**Technify  
Motors**

SB TMG 601-1007 P1, Rev. 4

**Service Bulletin No. / Date:** SB TMG 601-1007 P1, Revision 4 / January 06, 2016

**Subject:** Start Monitoring Loom and Mapping

Figure 1a

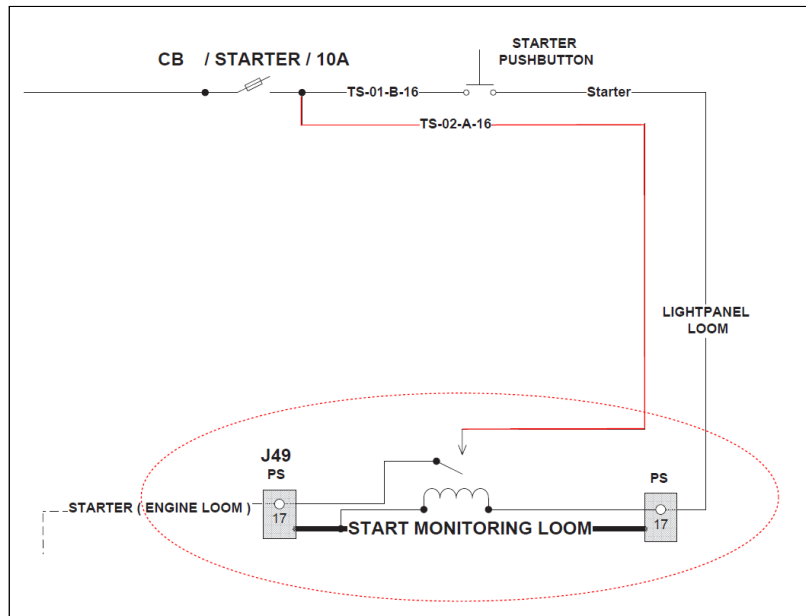
- Install the appropriate start monitoring loom behind the cockpit panel between light panel loom and engine loom in accordance with Figure 1a.

- Attach the start monitoring loom along existing cable bundles.
- Connect the main, excitation and FADEC backup battery.
- Install the new engine firmware TAE-125m3.30 (D48 FADEC) resp. D4-140 (D4 FADEC) or later version plus A/C related mapping. See TM TAE 000-0007.
